MILITARY SPECIFICATION

CONTAINERS, SHIPPING, REUSABLE: 8246020 AND 10539215

This amendment forms a part of Military Specification MIL-C-60104A(MU), dated 10 August 1967.

FIG. 1-CONTAINER ASSEMBLY

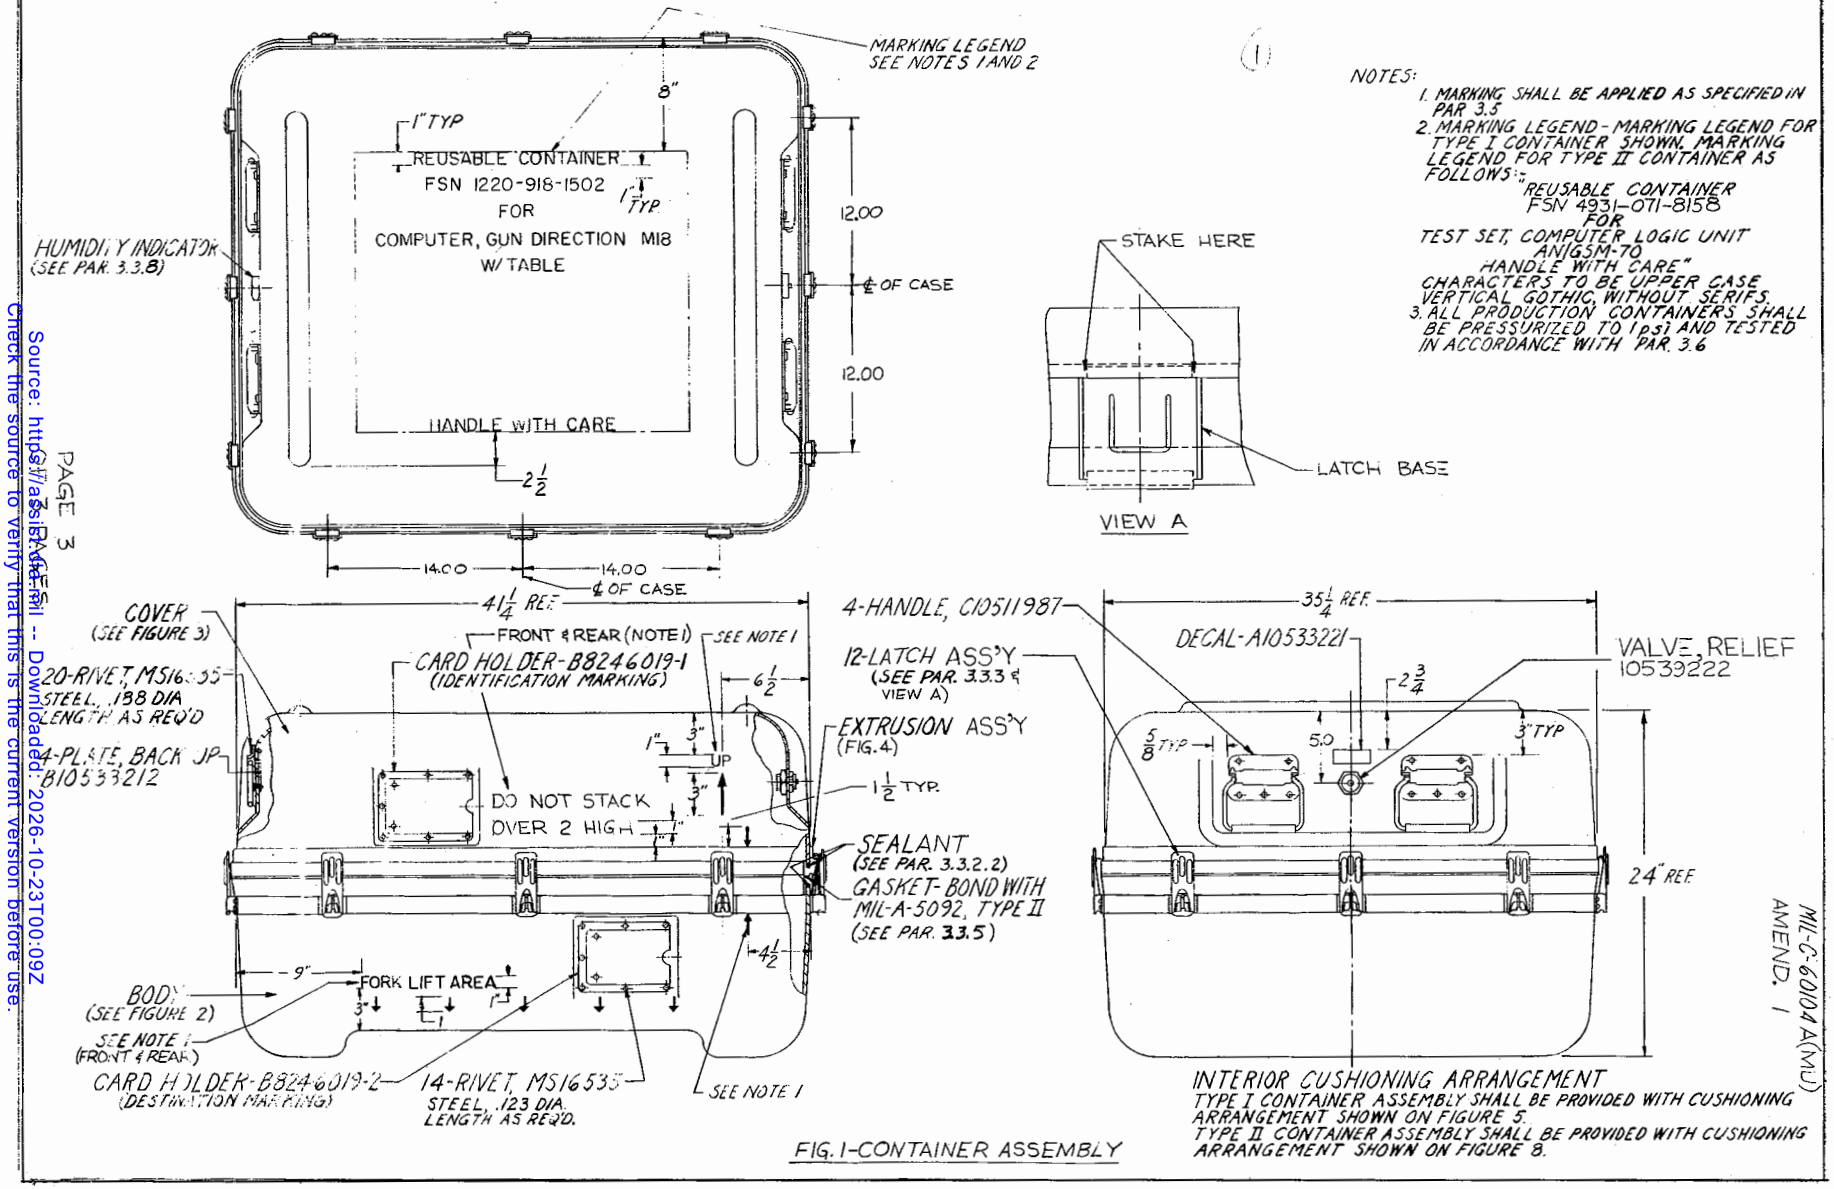
"3.3.3 Latches.- Twelve (12) latches conforming to Drawing C10556000 shall be located and secured to lower sealing extrusion as shown on Figure 1. The latch incorporates a spring detent in the base plate which engages into provided offset in sealing extrusion when the latch is positioned into the extrusion rail. Stake the extrusion rail in two (2) places to prevent lateral movement of latch base plate. Each latch shall be properly adjusted and cotter pinned to assure uniform pressure on sealing gasket. Touch-up paint shall be applied to stake marks with paint conforming to TT-E-529, Color X24087 of FED-STD-595.

"3.5 Marking.- Marking legends shown on Figure 1, shall be applied by silk screen or stencil with paint conforming to TT-E-529, Color White 27875 of FED-STD-595."

Delete: "Figure 1" and substitute attached "Figure 1".
